2211 SW 4TH

DESIGN REVIEW SUBMITTAL

MAY 27, 2016

**PREVIOUS CONCEPT PLAN
PRE-APPLICATION [EA 15-114048]
DESIGN ADVICE REQUEST [15-153663]**

PREVIOUS TYPICAL MAIN LEVEL PLAN

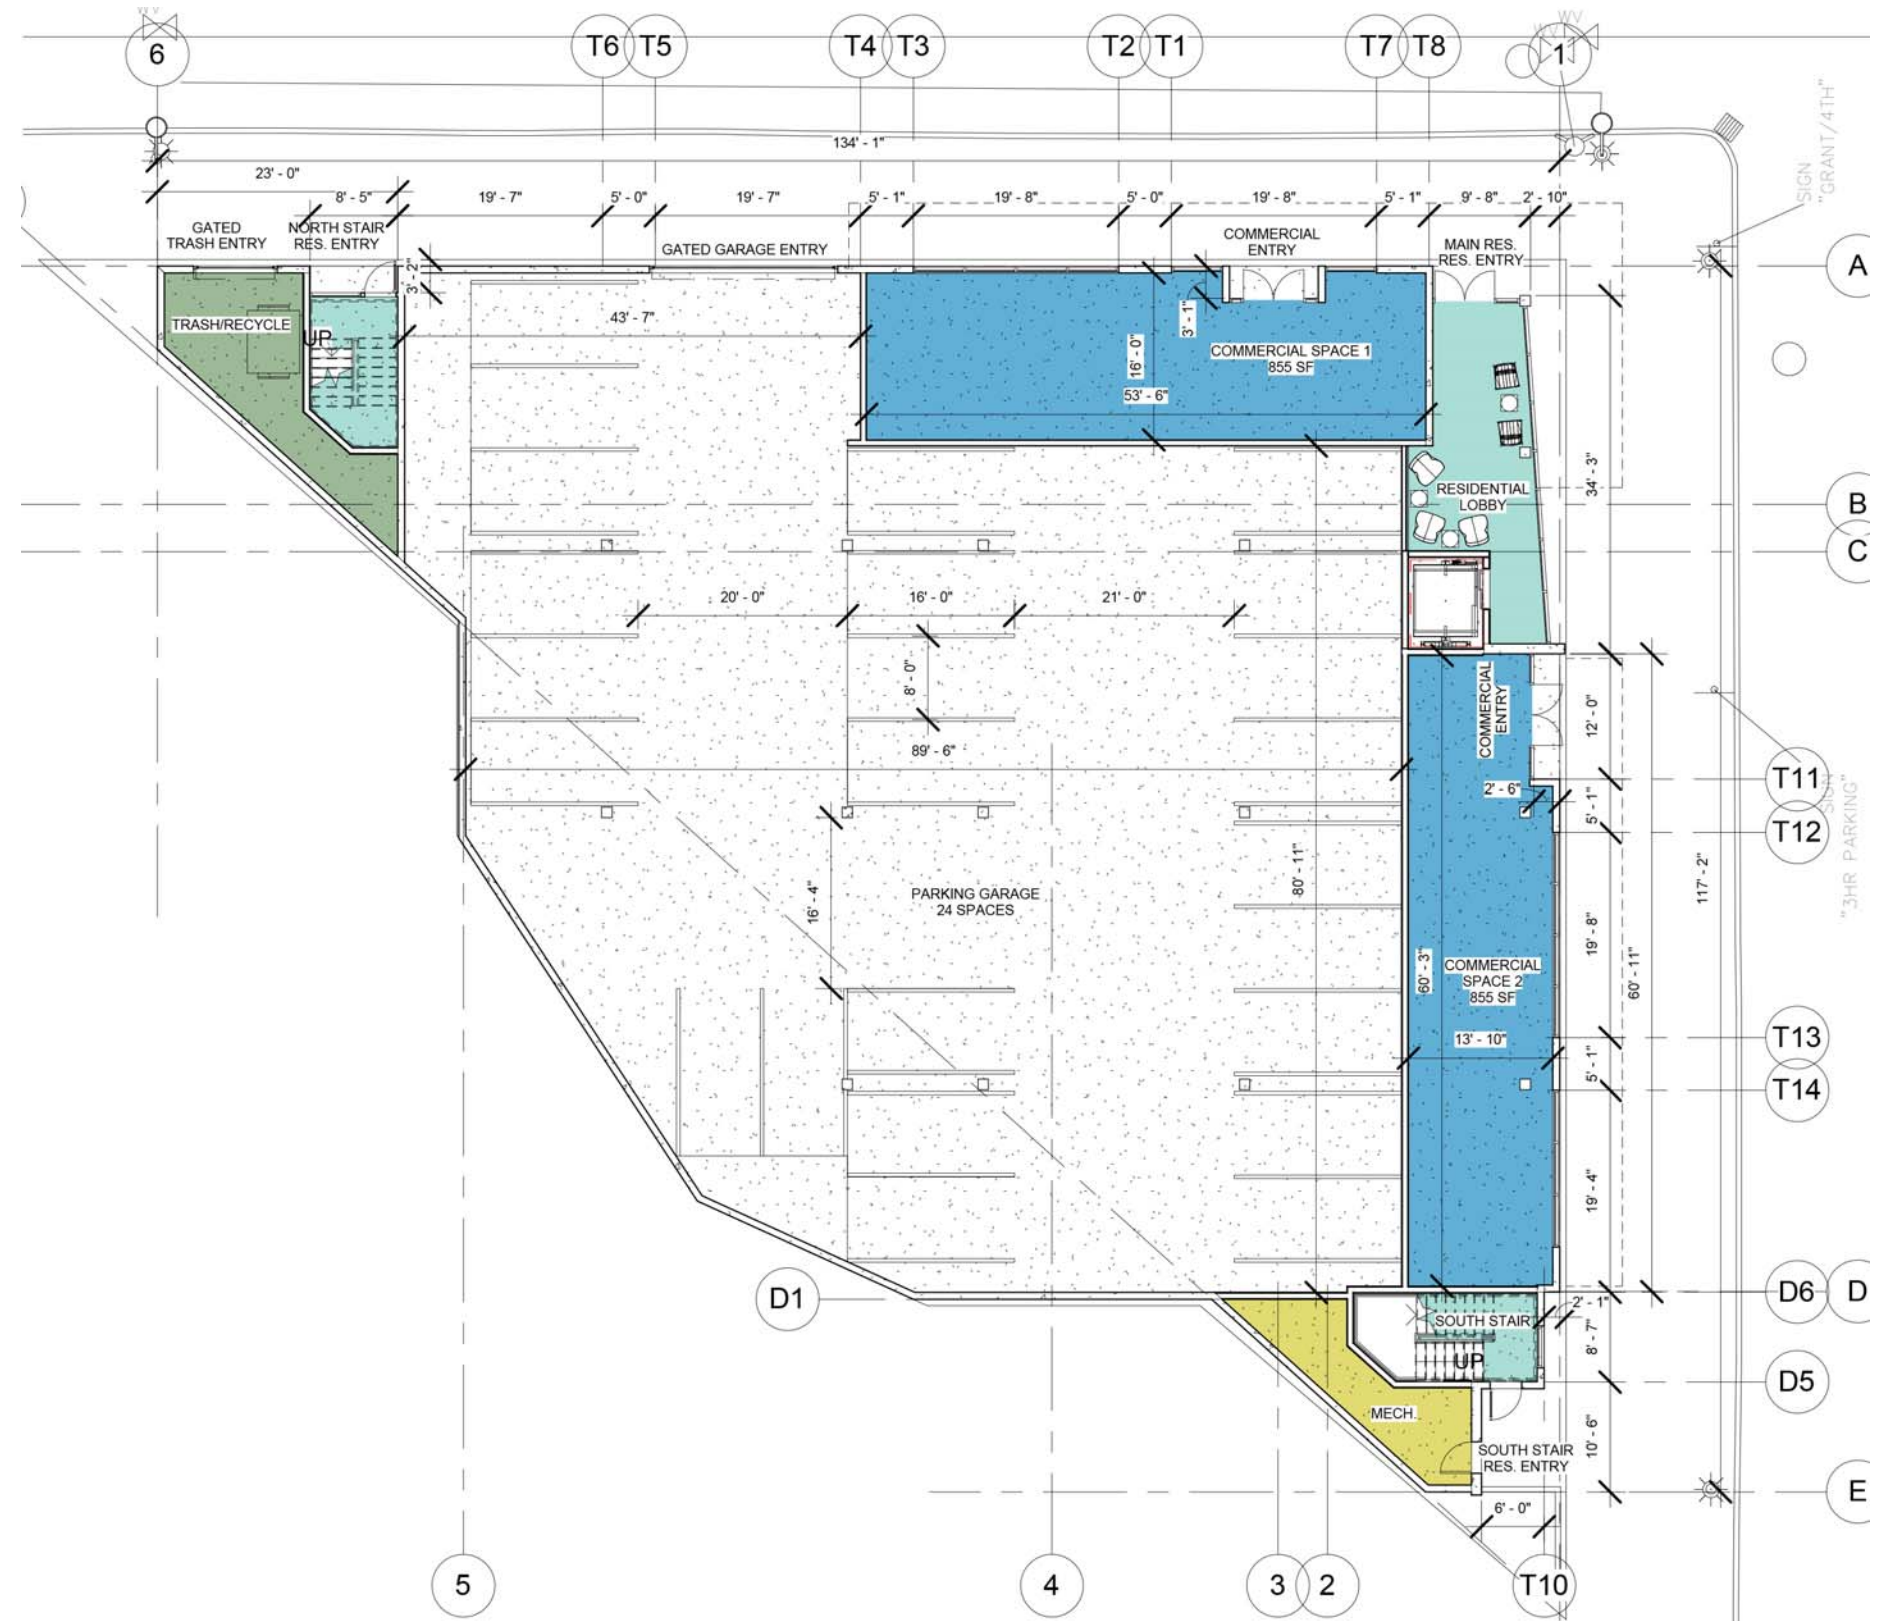
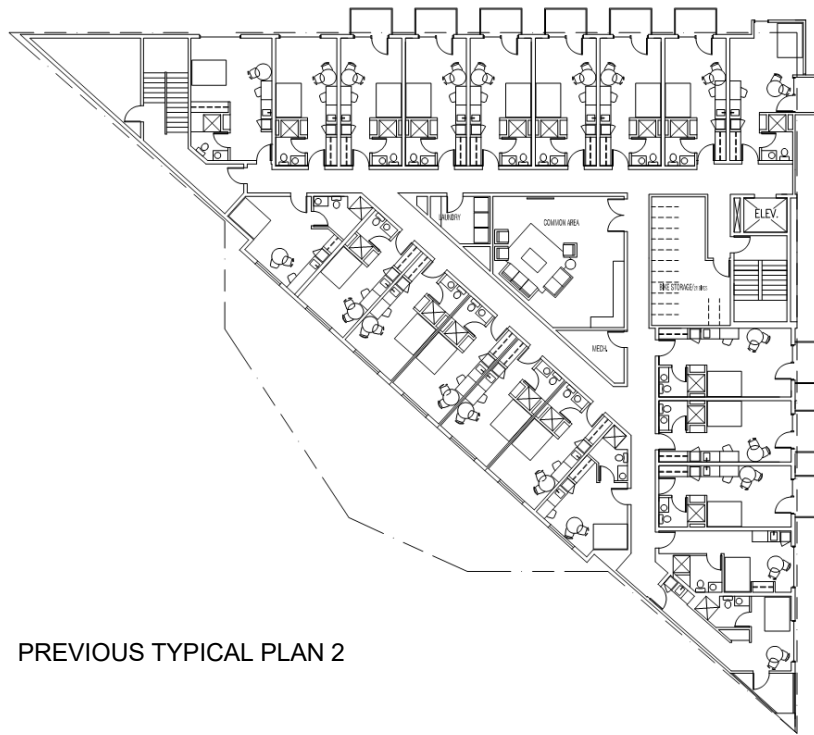
Comments:

- 1.) Reduction of driveway access to parking garage.
- 2.) Reduction of main level parking, increase of "active use" along 4th and Grant streets with increase of storefront glazing and building function along 4th and Grant.
- 3.) Wall angle and eroded corner of the main floor residential lobby emphasizes the pedestrian transition zone.

PREVIOUS TYPICAL PLAN 2

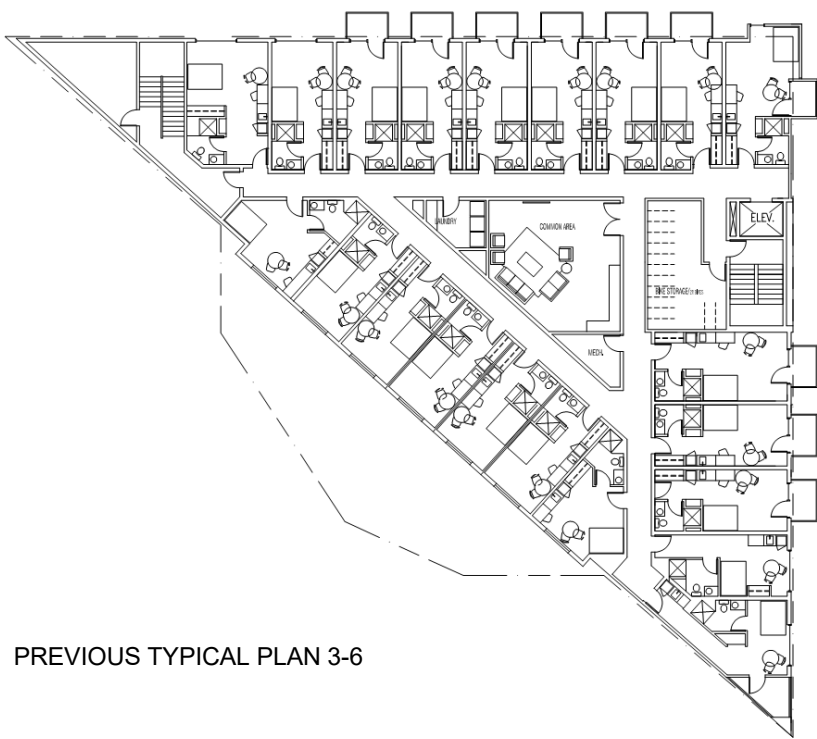
Comments:

- 1.) Revised shape of building to reduce building mass.
- 2.) Addition of second level exterior courtyard above grade level parking.
- 3.) Projection of balconies at 2nd level and above shall be less than 4'-0"
- 4.) Glazing wall and elevator lobby orientation.
- 5.) Configuration of dwelling unit interior to include bike storage.

PREVIOUS APPLICATION ELEVATION

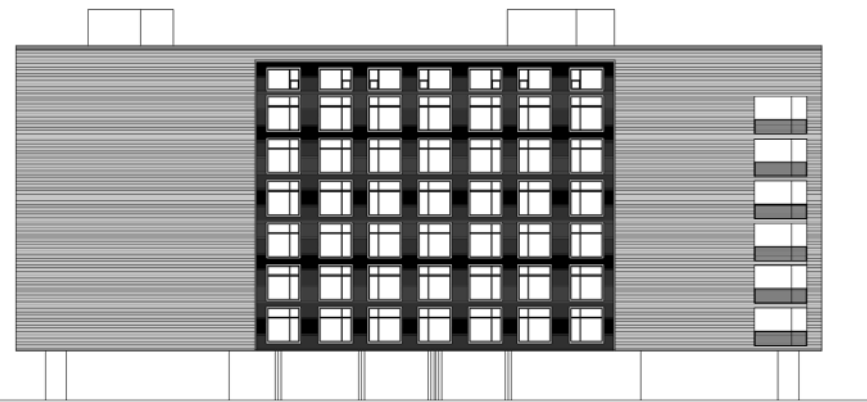
Comments:

- 1.) Massing Scale and Form - reduction in bulk.
- 2.) Materials: Suggestion to explore masonry based material to replace the metal as a primary cladding system.
- 3.) Rain Garden Planter on Building Wall.
- 4.) Ground level board form design - Better detailing is required.
- 5.) Vents and Louvers. Not clear how these are handled.
- 6.) Missing pedestrian amenities.
- 7.) Active corners.

- 1.) Revised shape of building to reduce building mass, shifts in material and facade help to reduce mass.
- 2.) The metal siding has been exchanged with masonry brick to become the primary cladding material, while the vertical ribbed metal becomes the accent material.

- 6.) Canopies, seating, and site amenities have been added and thoughtfully placed in a rhythm that compliments the architecture within the overall facade and at the pedestrian level.

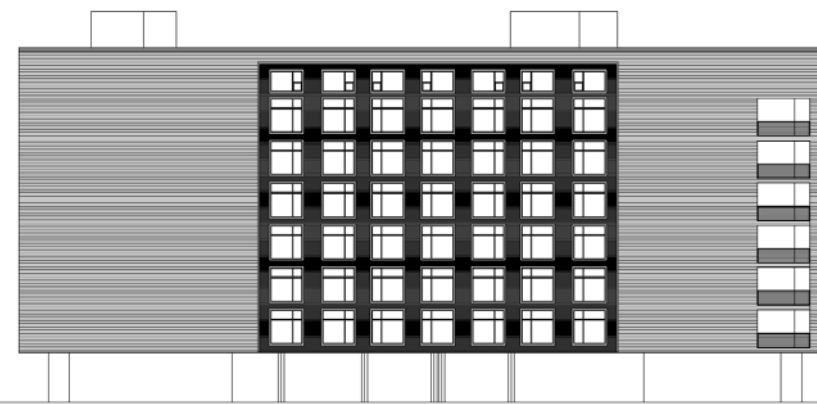
Comments:

- 1.) Massing Scale and Form - reduction in bulk.
- 2.) Materials: Suggestion to explore masonry based material to replace the metal as a primary cladding system.
- 3.) Vents and Louvers. Not clear how these are handled.
- 4.) South elevation treated like "back of house".

- 1.) Revised shape of building to reduce building mass, shifts in material and facade help to reduce mass.
- 2.) The metal siding has been exchanged with masonry brick to become the
- 3.) All vents and louvers for the residential floors are to be terminated through the roof to minimize penetrations in the facade. The exception to this rule would be free air vents within the VPI vinyl windows which would be integrated into the window and have very low visibility. Grade level vents and louvers are to be located in the spandrel glazing above the canopy, and at the pedestrian level.
- 4.) The South and West elevations, facing I-405, have been redesigned to provide more interest and architectural features. The shape of the building responds to its triangular site and has been optimized to reduce the overall mass from the former design.
